Thrumster Wastewater Scheme

Response to Submissions

Port Macquarie-Hastings Council

9 April 2025

FIGURE 3.1

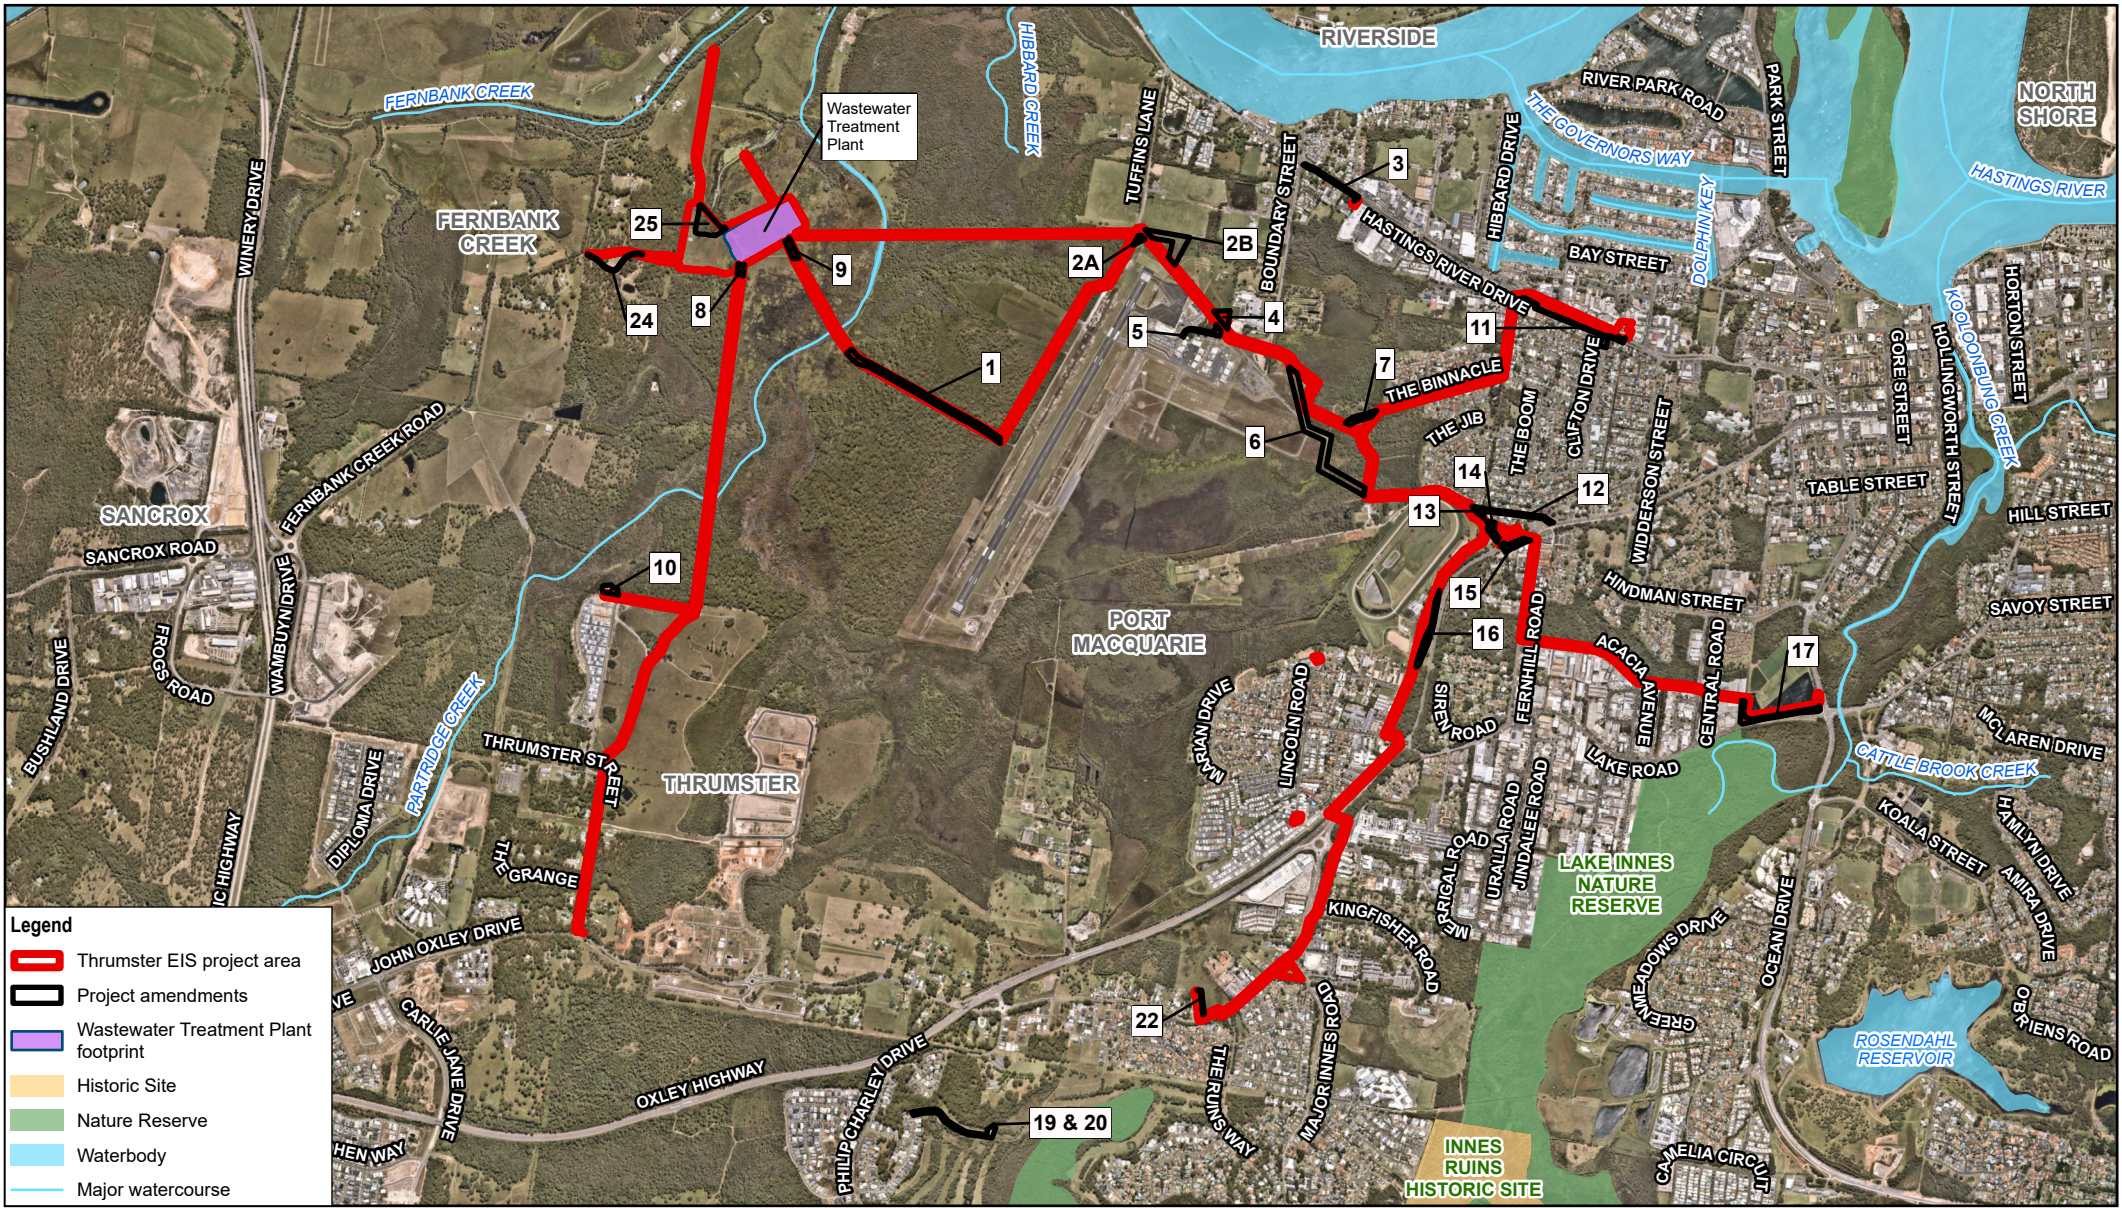
Amendments to the project footprint have been identified due to the development of the detailed design and ongoing consultation with agencies throughout the environmental assessment process. The proposed changes include a reduced laydown area adjacent to the proposed WWTP to minimise impacts to biodiversity and minor amendments throughout the pipeline network. These changes to the project footprint are shown in Figure 3.1 and outlined in Table 3.1.

Area	EIS footprint	Change to project footprint
1	Section of sewer rising main extending from the western boundary of the Airport towards Partridge Creek. This pipeline segment was proposed to be installed by open trenching and the disturbance footprint restricted to 6 m to minimise impacts to terrestrial and aquatic biodiversity within the broader 20 m project application corridor for the EIS.	Due to the development of design, the full corridor width in this location is required for all environmental investigations. This is to facilitate services and construction activities including vehicle movements and material handling. The change specifically relates to biodiversity assessment and offset calculations to increase the corridor width in this location from 6 m to 20 m.
2A	Section of sewer rising main and water main proposed to be installed around the north-western corner of the Airport. The pipeline segments were proposed to be installed by open trenching.	This minor amendment involves a small extension of the project footprint to the south of the proposed alignment. This is required to ensure the combined services corridor can be constructed without impacting on Crown Land (Crown Road adjacent to the southern end of Tuffins Lane).

4	A new sewer pump station (SPS87) was proposed in the EIS to the west of Newman Senior Technical College. This was proposed with a small construction compound. This is located adjacent to Tuffins Lane, where the return effluent pipeline and sewer rising main are proposed (trenching).	Due to the development of design, the project footprint is required to be extended for construction of the new sewer pump station (SPS87). This will provide additional space required for the construction laydown and associated equipment.
5	There was no works proposed in this section as part of the EIS.	Due to the development of design, a new section of power main is required. This power main would be installed via trenching. This area is in a highly industrial area and would follow an existing road (Oliver Drive).
6	A sewer rising main was proposed via open trenching along Tuffins Lane, following a southeast trajectory towards the Port Macquarie Racecourse. The EIS project footprint did not cover Area 6.	As a result of design development and consultation with the Port Macquarie airport regarding their future land use planning, a project amendment has been made to modify this section. The sewer rising main in Area 6 is on a modified alignment to that proposed in the EIS. The construction method for the proposed amendment is trenching.

7	The proposed sewer rising main was located via open trenching along existing access tracks within the Biobanking site. One main would be trending towards The Binnacle and the other towards Lady Nelson Drive.	This minor amendment is proposed following consultation with agencies to remove the impact on the BioBanking Site. This section is proposed to be modified to allow SPS07 sewer rising main to carry from the western end of The Binnacle through to Boundary Street. The proposed construction method would remain as open trenching.

Area	EIS footprint	Change to project footprint
8	This area is located to the south of the proposed WWTP. This section of recycled water main was proposed to be installed by HDD and the disturbance footprint restricted to 6 m to minimise impacts to terrestrial and aquatic biodiversity within the broader 20 m project application corridor for the EIS.	Due to the development of design, the full corridor width, of 20m in this location is required. This is to allow sufficient room for establishment and excavation of pits for Partridge Creek HDD crossing. The change specifically relates to biodiversity assessment and offset calculations to increase the corridor width in this location from 6 m to 20 m.
9	This section of sewer rising main was proposed to be installed by HDD and the disturbance footprint restricted to 6 m to minimise impacts to terrestrial and aquatic biodiversity within the broader 20 m project application corridor for the EIS.	Due to the development of design, the full corridor width, of 20m in this location is required. This is to allow sufficient room for establishment and excavation of pits for Partridge Creek HDD crossing. This is also required to allow for the TS01 sewer rising main cut-over works to the proposed WWTP. The change specifically relates to biodiversity assessment and offset calculations to increase the corridor width in this location from 6 m to 20 m.

10	This area was not proposed or assessed as part of the EIS. The location for Area 10 is to the north of Glenfern Ave which is part of the new Glenfern – Over 50's Lifestyle Community.	Due to the development of design, sewer pumping station TS01 requires upgrade works. This minor amendment would be added to the project footprint. It is located to the north of and adjacent to the proposed power and communications line to be installed via open trenching.
11	Section of sewer rising main was proposed to be installed via open trenching. This is proposed within the road reserve on the northern side of Hastings River Drive.	Due to the development of design, the sewer rising main has been changed from the north to south side of Hastings River Drive. This is to minimise the impact to existing services and traffic flows. The proposed amendment would make use of the existing service road that runs parallel with (and on the southern side of) Hastings River Drive. The proposed construction method would remain as open trenching.

Area	EIS footprint	Change to project footprint
17	Section of return effluent pipeline was proposed in the access track along the top of the effluent pond embankment. This area is parallel to Lake Road and within Council's fenced facility.	This amendment has been identified through development of detailed design. Due to potential safety risks associated with design adjacent to embankment, the new return effluent pipeline is now proposed to be located within the road reserve along Lake Road and Barton Crescent, outside of the fence, on road verge.
19 and 20	This location is south of the Oxley Highway, off Black Caviar Parade. Area 19 and 20 are new areas and have not been previously included in the EIS.	This minor amendment is required to facilitate minor construction works to the SPS80 site within the already disturbed footprint of SPS80. No vegetation removal would be undertaken at this site. The existing gravel vehicle access track SPS80 would be upgraded. No disturbance would be undertaken outside the existing access track.

24	The proposed design for the flood free access road was approximated in the EIS and was roughly a straight line through private property.	Two alternatives are now proposed as ongoing discussion with landowner is still underway. Therefore, consideration of both options for the flood free access road is being considered for assessment in the Amendment Report.
25	A large construction compound area was proposed in the EIS adjacent to the WWTP and within wetland areas to the north east.	As an outcome of agency consultation and to reduce environmental impacts, a reduction of the construction compound area is proposed. This amendment includes a modification of the proposed compound/laydown area to the east of the proposed WWTP site to predominantly avoid the mapped Coastal Wetlands along Partridge Creek. BCS recommended that the project area required for site compounds and laydown areas be reduced to prevent further impacts on potential Giant Dragonfly habitat.

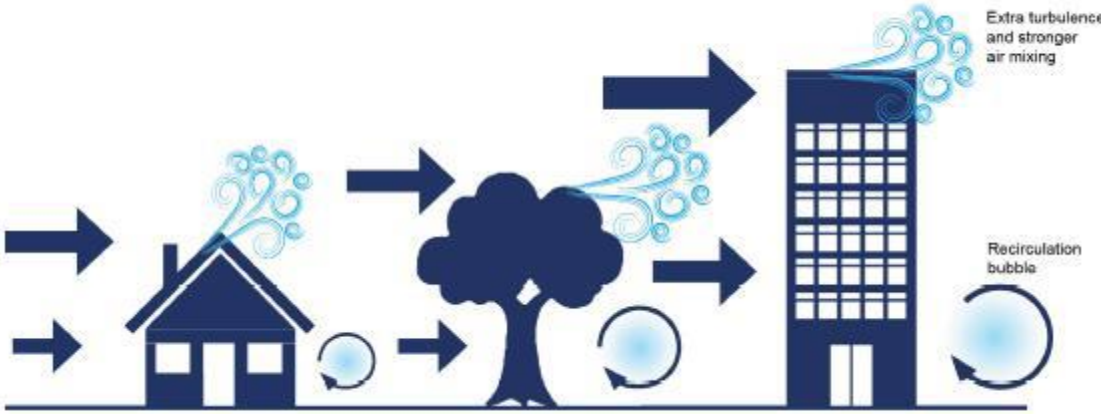
Key Issues	Comment		Response
Public Health and Safety Assessment	<i>The figures do not appear to be consistent or necessarily applicable. Figures 6.2 and 6.3 of Technical Report 12 are not specifically relevant to the type of work where dust generation is likely to be from the ground. (i.e. not a smokestack).</i>		<p>During construction, the main potential for impact on air quality is the release of dust/particles into the air during earthworks. This is a common issue during most construction works (GHD 2024a).</p> <p>During operation of this facility, the main potential impact on air quality is the possibility of odours from the facility (GHD 2024a).</p> <p>The air quality assessment included:</p> <ul style="list-style-type: none"> – Review of the existing environment (land use, ambient air quality and meteorology). – Review of the proposed construction methodology including equipment and processes. – Identification of construction activities which may lead to emissions. – Identification of nearby sensitive receptors to construction activities. – A qualitative air quality assessment with a focus on construction particulates and dust. – Review of operational activities and identification of sources of odour emissions. – Identification of project specific mitigation measures to manage the potential for dust and odour impacts (GHD 2024a). <p>The assessment was undertaken in line with government guidance – in this case:</p> <ul style="list-style-type: none"> – Approved Methods for the Modelling and Assessment of Air Pollutants in New South Wales (NSW EPA 2022). – Guidance on the assessment of dust from demolition and construction from the UK Institute of Air Quality Management (IAQM 2024). – Technical Framework for Assessment and management of odour from stationary sources in NSW (NSW DEC 2006a). <p>Assessment criteria for dust/particles and for odour were taken from the Approved Methods Manual (NSW EPA 2022).</p> <p>Estimating odours or pollutants in off-site areas involves information such as:</p> <ul style="list-style-type: none"> – Odour/pollutant concentration (or emission rate) at the facility. – Information about the meteorological conditions. – Information about the terrain in the surrounding areas. <p>This information is used to estimate how the pollutants/odours are mixed and transported in the air and the concentration that may be present at ground level at different locations.</p> <p>Particles, pollutants and/or odours get into the air via point sources such as stacks or chimneys or via diffuse sources such as lift off from the ground or stockpiles when windspeed is sufficient. Air dispersion modelling can be used to estimate concentrations in air of particles, pollutants and/or odours due to either point sources or diffuse sources.</p>

Key Issues	Comment		Response
			<p>Once in the atmosphere the particles, pollutants and/or odours get mixed into and transported through the atmosphere due to the action of the wind and rain and the movement can be impacted by buildings or large vegetation. Figure 4.1 shows this mixing as particles, pollutants and/or odours move with the wind through the atmosphere once emitted or discharged. This is how particles, pollutants and/or odours move from a site where relevant activities are being undertaken to the local community around the relevant project site.</p>  <p>Figure 4.1 How wind moves particles, pollutants and/or odours through the atmosphere via wind and the turbulence generated by the interaction of wind and buildings or vegetation (NSW Chief Scientist 2018)</p>
	<p>Confirm and detail the consultation that has been undertaken with the Food Standards Authority regarding the potential impacts of discharge of effluent to the Hastings River and the surrounding oyster leases.</p>		<p>Consultation regarding oyster leases was undertaken for the project as follows:</p> <ul style="list-style-type: none"> – GHD issued an invitation to NSW Fisheries and NSW Food Authority in relation to this project – providing a description of what was proposed and seeking their input. – Both NSW Fisheries and NSW Food Authority staff were invited by Council to the planning focus meeting held at the beginning of this project. – In relation to NSW Food Authority staff, the particular staff that were invited and with whom consultation continued via Port Macquarie Hastings Council and others in the project team during the development of the EIS were Phil Baker and Anthony Zammit (Acting Manager and Manager NSW Shellfish Program).

Plate 8: a) Site K08 facing upstream of Kooloonbung Creek, b) Site K08 facing downstream of Kooloonbung Creek at High Tide and Low Tide

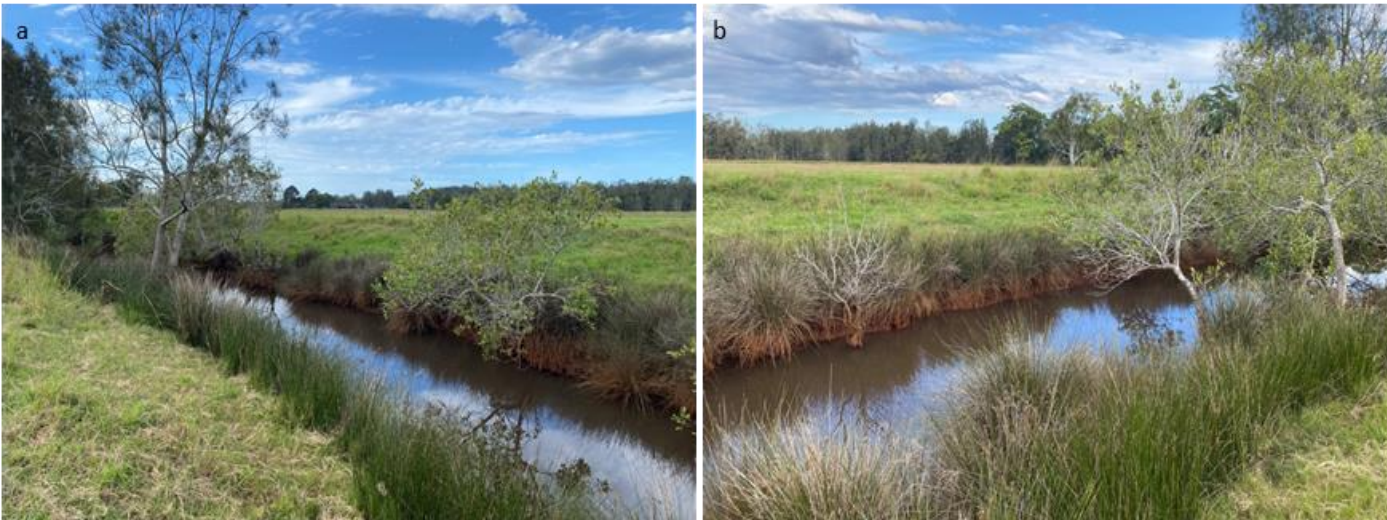
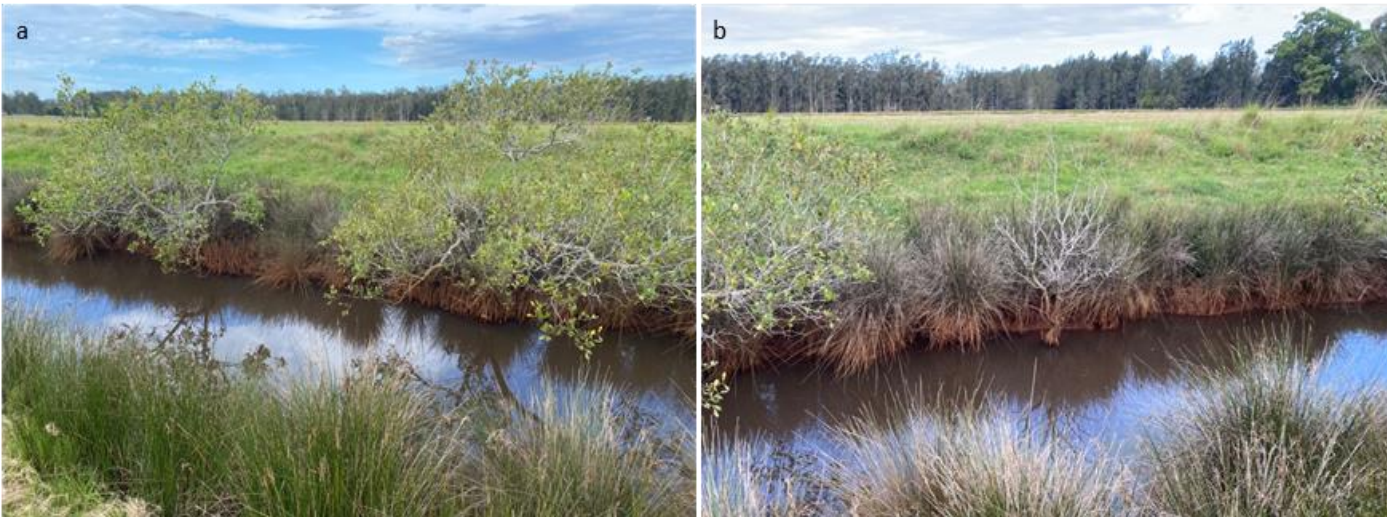
Key Issues	Comment		Response								
	<i>The photos provided in Technical Report 6 are not at high and low tide as per the SEARs. Please update as required.</i>		Survey sites investigated in the Technical Report 6 – Aquatic Ecology Assessment included seven sites within the tidal limit of Kooloonbung Creek (K01-K07) and one site at the estimated tidal limit of the Partridge/Fernbank Creek man-made connection (K08). Other sites at Partridge Creek are freshwater habitats above the tidal limit and not affected by tides (P09-P12). Photos facing upstream and downstream at high and low tide at the 8 sites noted are provided in Appendix C-2 (Appendix 1).								
	<i>The cumulative impacts to aquatic ecology do not appear to have been adequately addressed. Aquatic ecology is not specifically addressed within Section 24 of the EIS and other developments and cumulative impacts are not addressed within the aquatic ecology assessments.</i>		<i>This response should be read in conjunction with Section 4.4– Response to relevant comments from NPWS, which addresses cumulative impacts associated with Kooloonbung Creek.</i> Cumulative impacts to aquatic ecology and other developments have been addressed in Appendix C-2, Section 2d.								
	<i>Are any offsets proposed to be applied? Provide information about how offsets may be proposed to be applied.</i>		<p>An updated Project Area with altered footprint for the Thrumster WWTP and pipeline was provided by Council following the EIS Submission (see Appendix C-2, <i>Appendix 2 – Figure 1</i>). The updated Project Area reduces the amount of KFH that will be directly and indirectly impacted by the proposed scheme, with new areas shown in Table 4.3. This includes a modification of the proposed compound/laydown area at the Thrumster WWTP site to predominantly avoid the mapped Coastal Wetlands along Partridge Creek. Adjustments in the pipeline alignment also now avoids some sections of Type 1 KFH (as mapped Coastal Wetlands) and Type 3 KFH along the RTEP, SRM and RWM to the east of the Airport adjacent to Boundary Street and the RTEP, SRM and RWM in two small areas north of the Port Macquarie Racecourse.</p> <p>Table 4.3 Updated approximate direct and indirect impacts to KFH as a result of construction works</p>

Figure 1. Changes in Giant Dragonfly impact by the project.

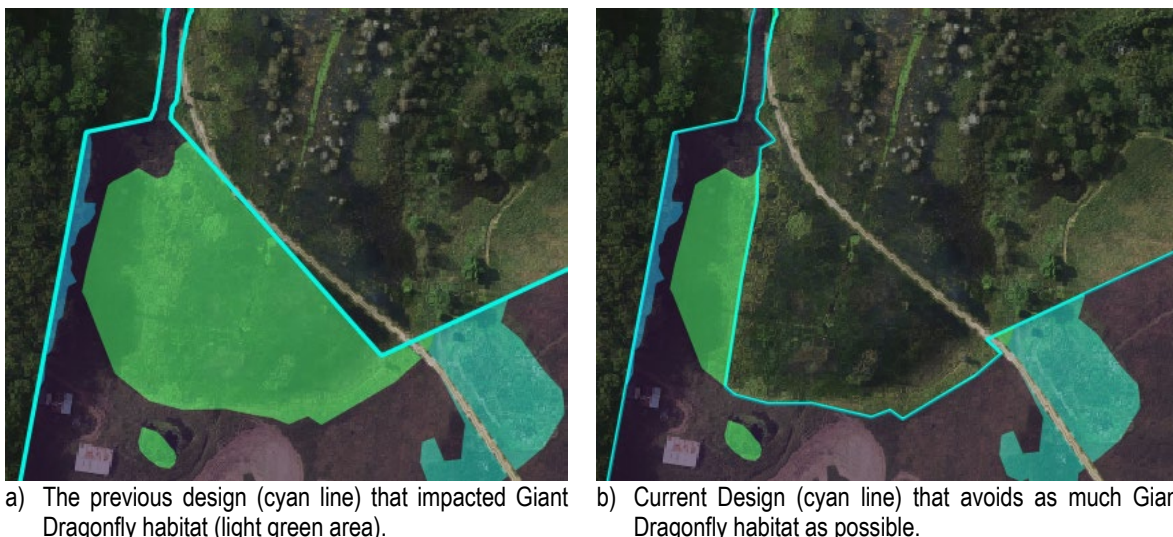
Following review of the BDAR, BCS raised concern that the project could cause a SAIL for Giant Dragonfly. The BDAR had addressed Sections 7.1 and 7.2 of the BAM by reassessing the need to use the Partridge Creek Site and completely revising the method of wastewater treatment from using a treatment wetland to discharging at Kooloonbung Creek.

BCS recommended that the project area required for site compounds and laydown areas be reduced to prevent further impacts on potential Giant Dragonfly habitat. de Witt Ecology has discussed this option with the client and confirmed that further avoidance could occur in this location and has provided guidance on the extent that Giant Dragonfly habitat could be further avoided (Figure 1). The avoidance has reduced direct impacts on 1.04 ha of PCT 3967, with avoidance taken for the full extent of the vegetation zone where possible.

Following this change a revised BDAR will be submitted to the department. This revised document will detail the changes and update the SAIL assessment to be clear and accurate.
